## Agenda Item #5

### Application 2024-32-CA

1001 Oak Street

Reopen front porch; construct new rear porch; fenestration changes on rear elevation.

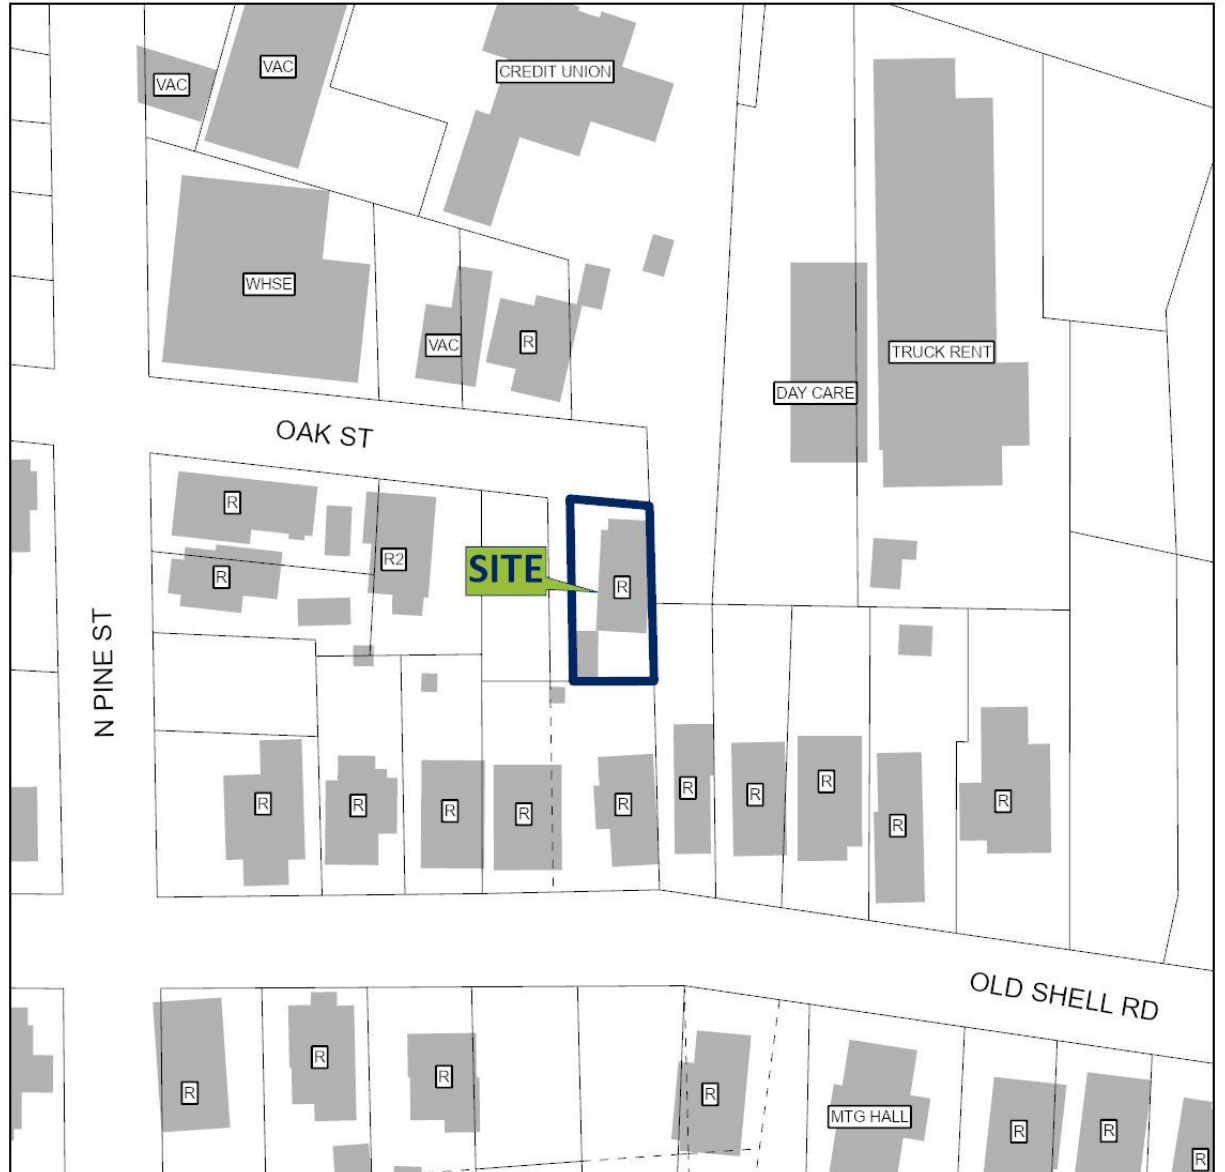
The application also includes the construction of a rear porch addition. The inferior height and slope of the porch addition, along with its foundation height are compatible with the existing building and do not visibly interfere with the integrity of the structure. The porch would be attached to a later rear addition and would not disrupt the massing or historic form of the structure. The proposed hipped roof is suited to the existing home and incorporates exposed rafter tails similar to those on the existing structure. Likewise, the proposed materials of wood and brick are compatible with the existing building. (6.17,6.18)

In reference to the wholesale removal of the existing fenestration on the rear (south) wall, the *Residential Design Guidelines* state, "For most contributing properties in historic districts, the windows that are on the front elevation and those on the sidewalls that are visible from the street will be the most important to preserve. Windows in other locations that have distinctive designs and that represent fine craftsmanship may also be important to preserve." (p.40) The application proposes the removal of the doors and windows located on the rear end wall of a later addition, which is not visible from the street. Additionally, the design of the subject windows does not stylistically complement the original structure. The submitted plans show that the removed door would be relocated to the front entryway and restored.
